Access Compliance Report

Public Rights-of-Way

(Curb Ramps)

Intersection ID: 53019	Main Street: BILLET_LN	Cross Street: CHARTRES_LN	Location: SW
ADA ID: D337A2C85380	Ramp Type: BlendTrans2	Initial Pass/Fail: Pass	Overall Compliance: No
Codes/Mitigation Info/Possible Solution		Field Measurements/Component Compliance	
Severity Score: 7.5

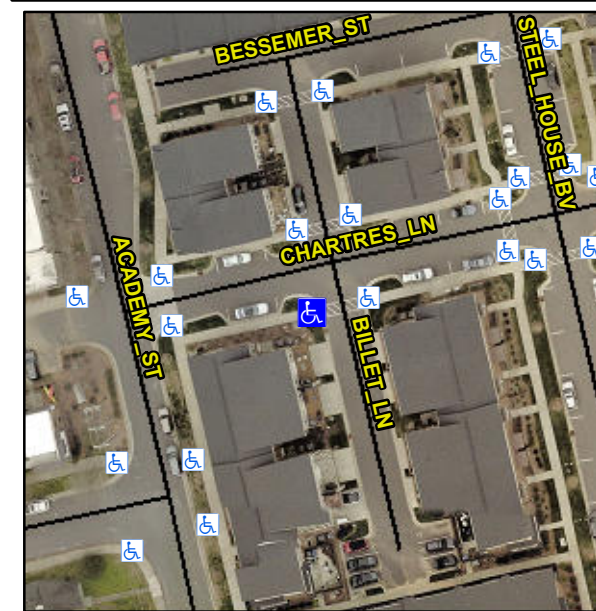
Not Found, R305.1.4, R305.2, R304.5.4

Compliance	Description	Data	Compliance	Description	Data
N/A	Ramp Length (in)	25.5	Yes	BlendTrans Slope (%)	4.1
Yes	Ramp Width (in)	66.0	Yes	BlendTrans XSlope (%)	1.6
N/A	Flare Type LT	None	N/A	Flare Type RT	None
N/A	Flare Slope LT (%)	N/A	N/A	Flare Slope RT (%)	N/A
N/A	Flare Traversable LT?	N/A	N/A	Flare Traversable RT?	N/A
N/A	Landing Length (in)	N/A	Yes	DWS Provided?	Yes
N/A	Landing Width (in)	N/A	Yes	DWS Contrast?	Yes
N/A	Landing Slope (%)	N/A	Yes	DWS Length (in)	24.0
N/A	Landing X Slope (%)	N/A	No	DWS Full Width?	No
N/A	Landing Curb? (Y/N)	No	No	DWS Offset (in)	7.5
N/A	Shared Landing?	No			
Yes	Gutter Ponding?	No	No	Gutter Slope (%)	10.6
Yes	Gutter Lip Ht (in)	0.0	Yes	Gutter X Slope (%)	0.1
N/A	Painted X Walk1?	Yes	N/A	Painted X Walk2?	N/A
	X Walk 1 Direction	To E		X Walk 2 Direction	N/A
	X Walk 1 Width (in)	68.0		X Walk 2 Width (in)	N/A
	X Walk 1 Slope (%)	2.2		X Walk 2 Slope (%)	N/A
	X Walk 1 X Slope (%)	2.1		X Walk 2 X Slope (%)	N/A

Yes	Ramp inside XWalk1?	Yes	N/A	Ramp inside XWalk2?	N/A
	Road Slope (%)	2.1		Clear Space?	Yes
	Road X Slope (%)	2.2	N/A	Clear Space to XWalk (in)	N/A
Yes	Any Obstructions?	No	Yes	Storm Grate/Utility Hazard?	No
	Obstruction Type			Storm Grate/Utility Type	
		N/A			N/A
			Yes	Surface Condition? (G/P)	Good
			No	Curb Slope (%)	14.8

Remove & Replace Curb Ramp With Two New Directional Ramps or Equivalent. Remove & Replace Gutter.
